Addendum #3

Project: OAHS – 321 John St, Cobourg

Project No.: 251088

Date: June 29, 2026

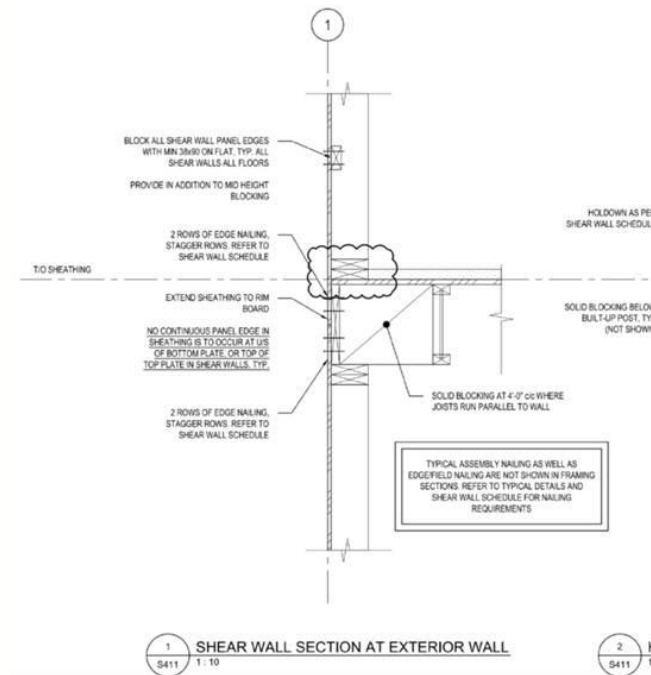
2. The fire-retardant requirements are in two places in Section 06 11 00:
 - **The product spec** — Section 2.1 Materials, clause .8 (page 5): Fire-retardant treatment of lumber and plywood (interior and protected locations) is to be 'Dricon FRT' fire retardant treatment by Biewer Lumber or approved

alternative, conforming to **ASTM E84**, to provide a **flame spread rating of 25 or less**.

- **Where it's used** — Section **3.3 Miscellaneous Woodwork**, clause **.6** (page 7): use fire-retardant lumber for blocking/framing in **ceiling spaces, partitions, and bulkheads**. Also **3.6 Backboards** (page 7): plywood backboards are primed and painted white both sides with **fire retardant paint** — note that's a painted finish, not FRT-treated plywood, so it's a different item.

If Dricon is required, a few practical details worth attaching:

The Dricon spec is explicitly limited to "interior and protected locations." FRT chemistry isn't for weather-exposed use, which lines up — exterior and below-grade wood falls under the pressure-treatment clause (2.1.3, copper-based to CAN/CSA O80) instead, not FRT.

*Fasteners and connectors in FRT wood must be **hot-dip galvanized to CAN/CSA G164-M** (clause 2.1.9.5, page 5). FRT chemicals can be corrosive to plain steel, so this matters for hardware line items.*

*Each piece of fire-retardant-treated lumber must be **shop-marked with the ULC monogram** per CAN/CSA O80-M (clause 1.5.6, page 3). Does this require each piece of blocking to be shop-marked?.*

Responses #3.27 and #3.28: None of the structural lumber should be pressure or fire-retardant treated. 06 11 00 only requires fire-retardant treatment for non-structural framing (fire block partitions, ceiling down-framing, bulkhead framing, etc). Also refer to **Response #3.1**.

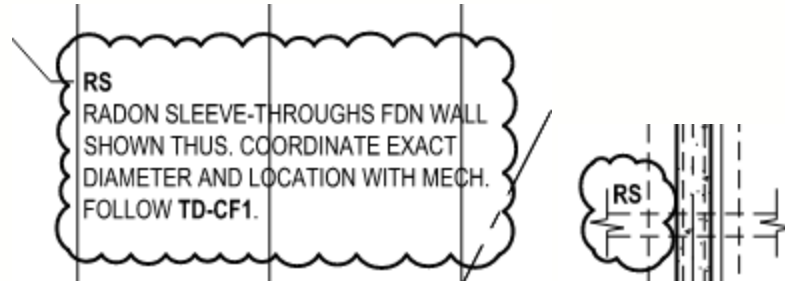
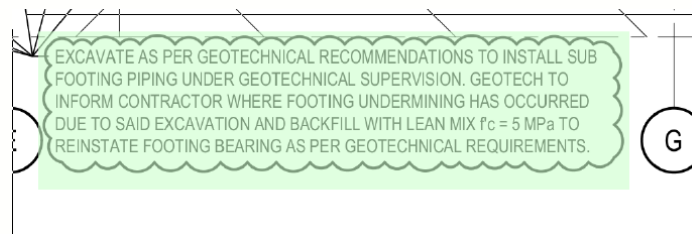
Question #3.29: *On structural drawing S201, there are notes on foundation sleeves for radon referring to geotechnical recommendations to install sub footing piping. We did not find any recommendations on radon piping in geotechnical report. Please advise.*

Response #3.29: Mechical drawings show radon as sub slab, not sub-footing. This is the note relevant to radon sleeves. Radon sleeves marked with "RS" in the addendum drawings.
